Addendum 1

Jackson County
Gum Springs Park– Phase 1

This Addendum is hereby made a part of the Contract Documents.

SHEET NUMBER
C-8.18

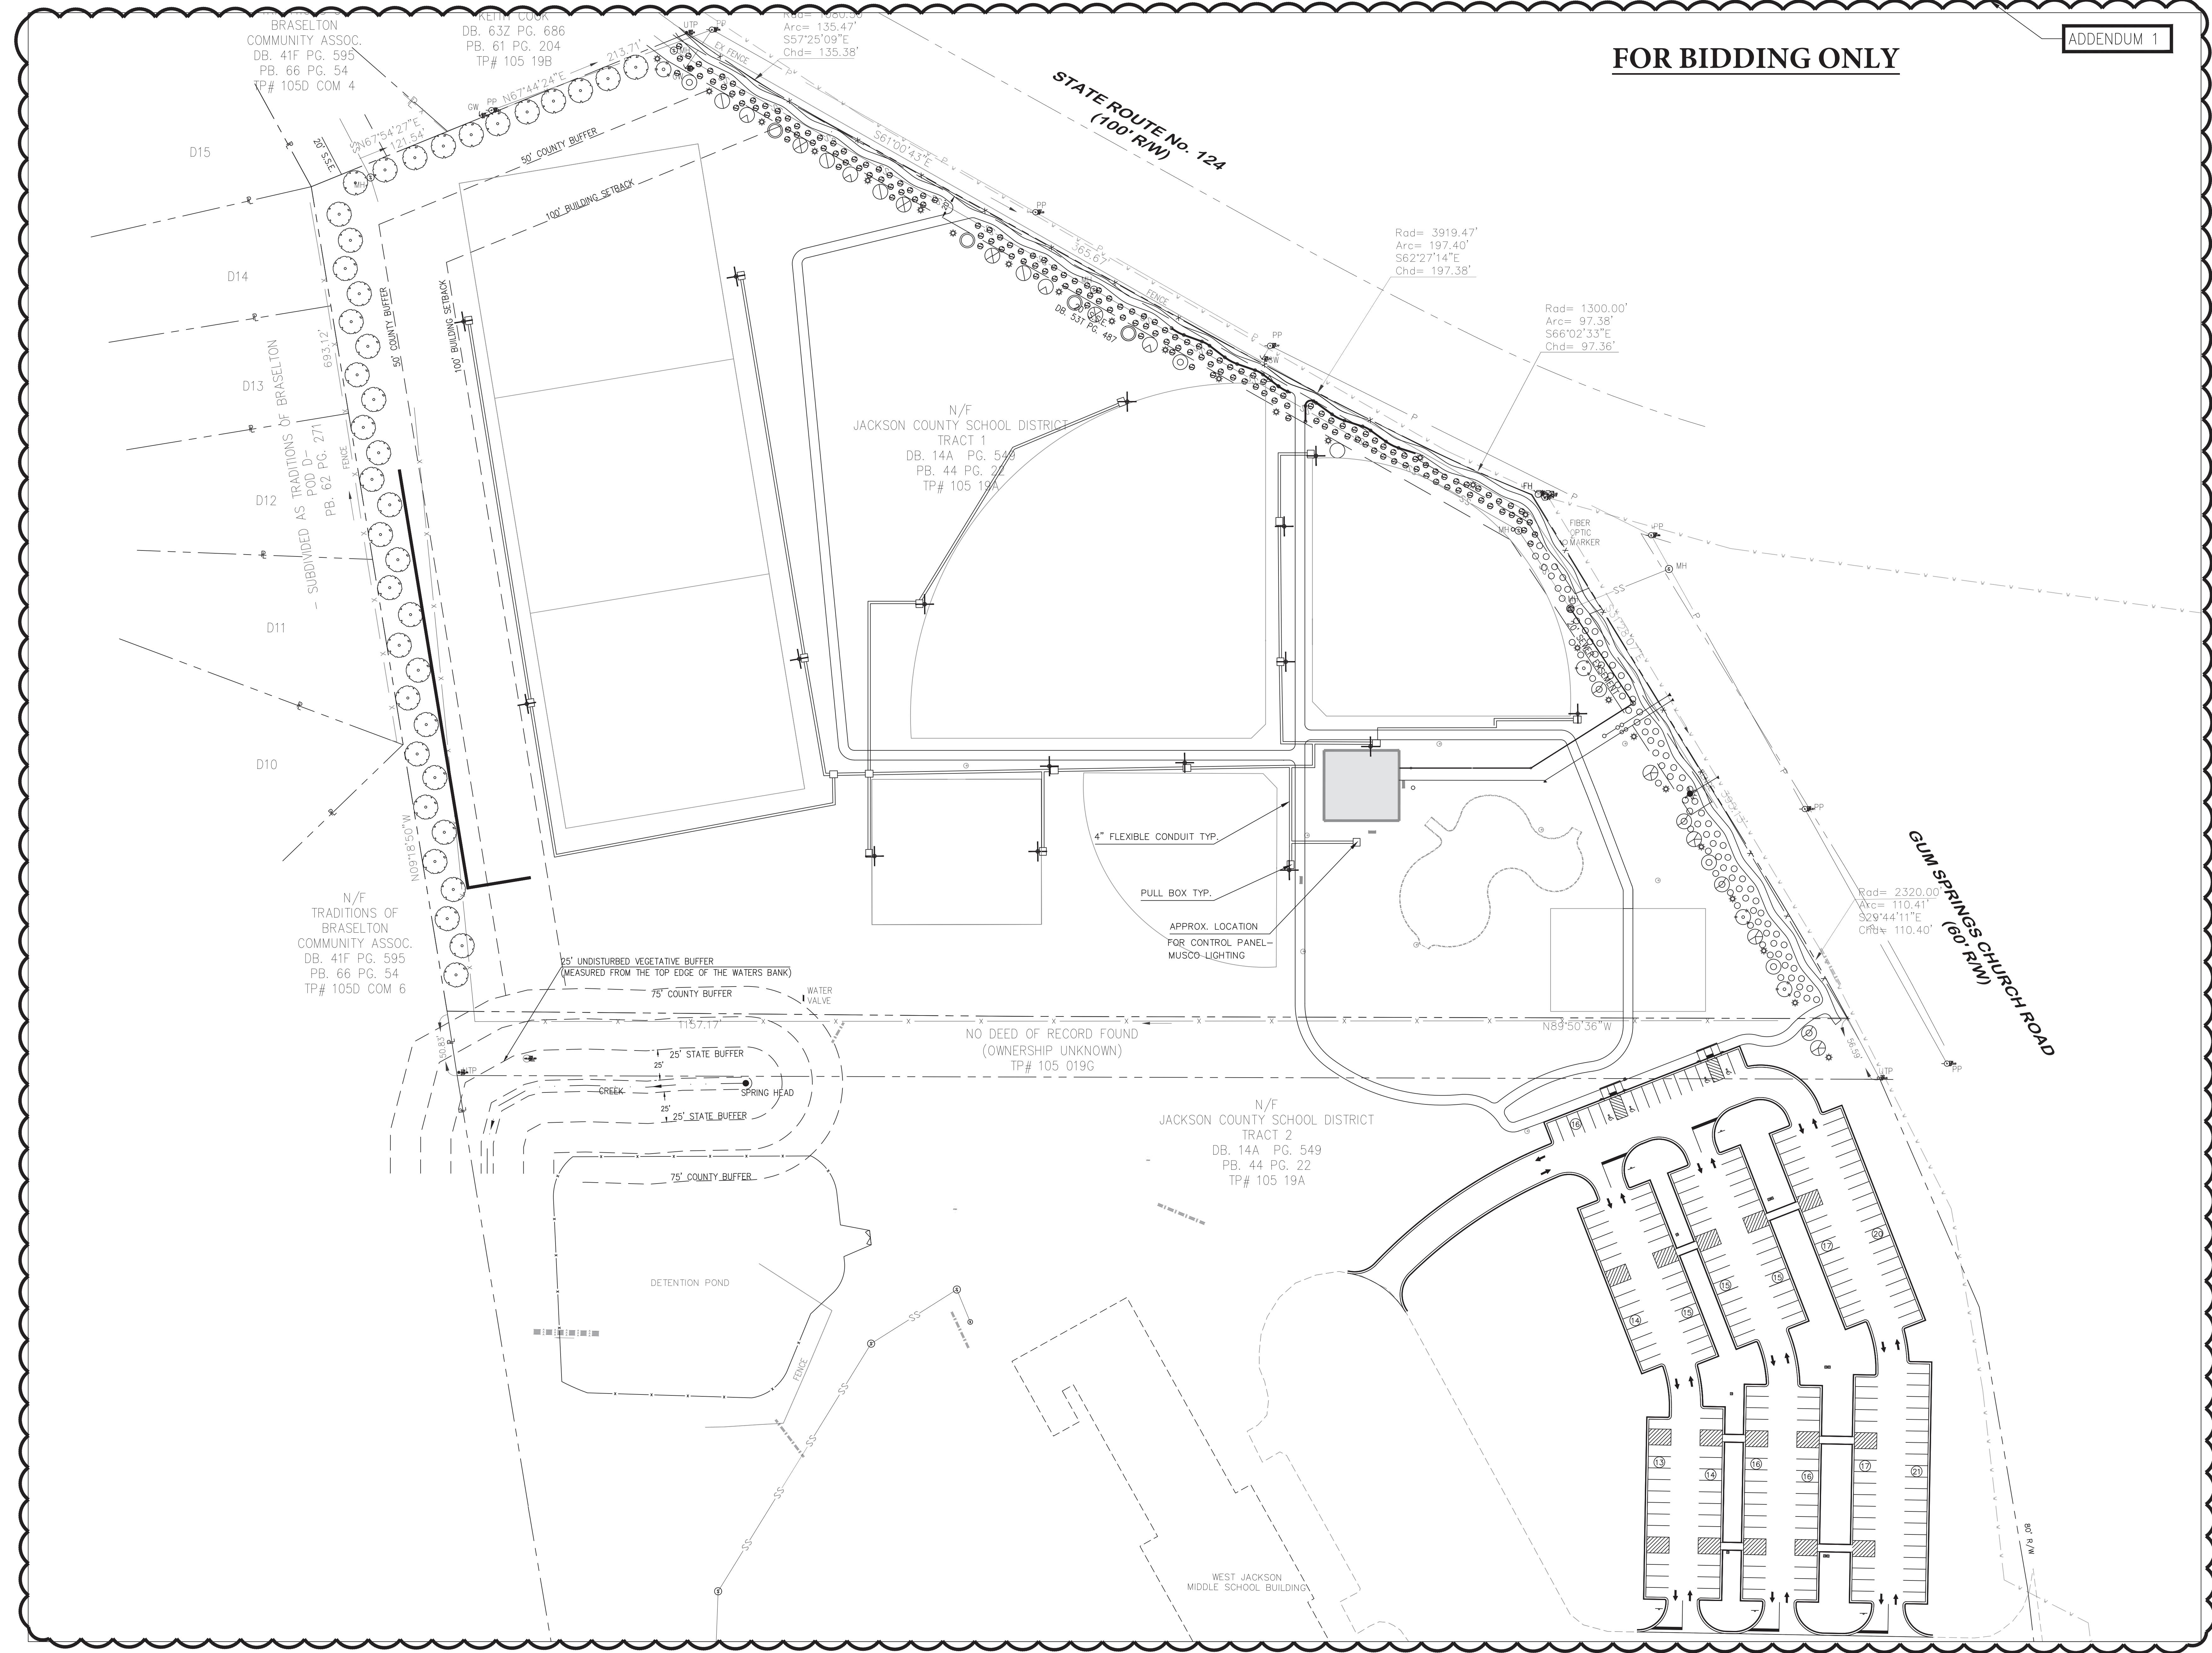
5. Q: When is the deadline for questions?
A: Deadline for questions is Friday, July 3.
6. Q: Is the pedestrian lighting/sports lighting in this contract and do I need to price it?
A: Pedestrian lighting will be in this contract. Sports lighting will not be in this phase, however, installation of the conduit and pull boxes will be included in this phase. See attached exhibit C-8.18.

9. Q: Is the site classified or unclassified?
A: Classified, Unit prices for unknowns must be provided on the bid form.
10. Q: Can we get clarification on the placement and details for the sports lighting conduits?
A: See attached C-8.18.

1. Electronic Data File Transfer, User and Indemnification Agreement
2. Pre-Bid Sign-in Sheet
3. Revised Specifications
 - 00300 Bid Proposal Form
 - 01 2200 Unit Prices
 - 26 5668 Exterior Athletic Lighting
 - 32 1813 Seeding and Sodding of Lawns
 - 32 3113 Chain Link Fence and Gates
 - 32 3123 Vinyl Fence
4. Revised Civil Plans
 - C-0.0
 - C-3.0 - The 4-rail wood fence has been changed to a 3-rail white vinyl fence.
 - C-4.0
 - C-5.0 -The service sewer line has been changed from DIP to PVC, SDR 26.
2” gate valve was removed from the domestic and irrigation line in the plans. The gate valve is included in water meter provided by JCWSA. The PIV from the Fire Hydrant line was removed.
 - C-6.6
 - C-7.1
 - C-8.3
 - C-8.10 to C-8.18- Provided location of sports lighting conduits and boxes.
 - T-1.0
